Product Change Notification

PCN-ICC-3282-2019

Business Unit	Product Line Code	Type of Change	Action	Date of Issue
ICC - Industrial Cabinet	BE2	Product Change Notification	Notify Distributors and Field	2/18/2019

Description for Product Change Notification

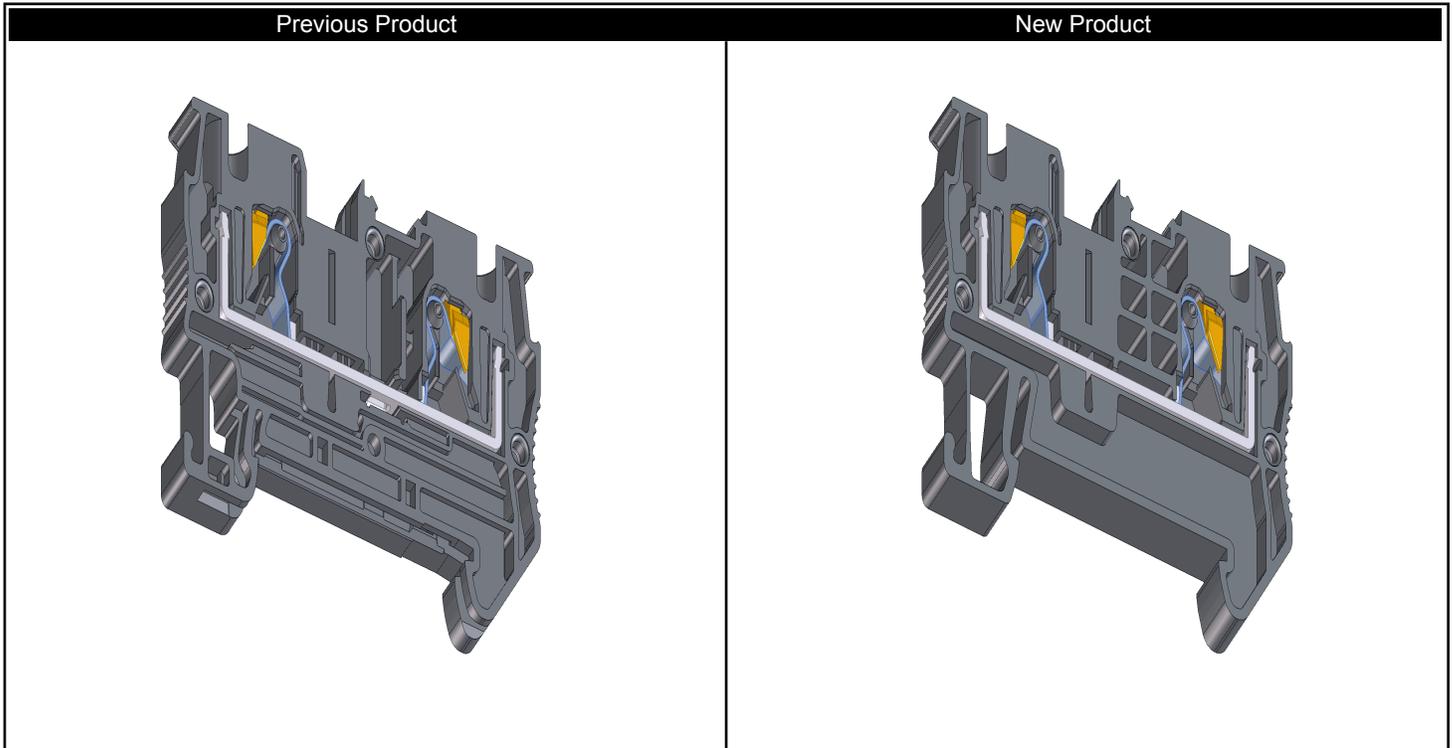
A housing change has been implemented to remove the slot for the PE foot on non-ground version terminal blocks.
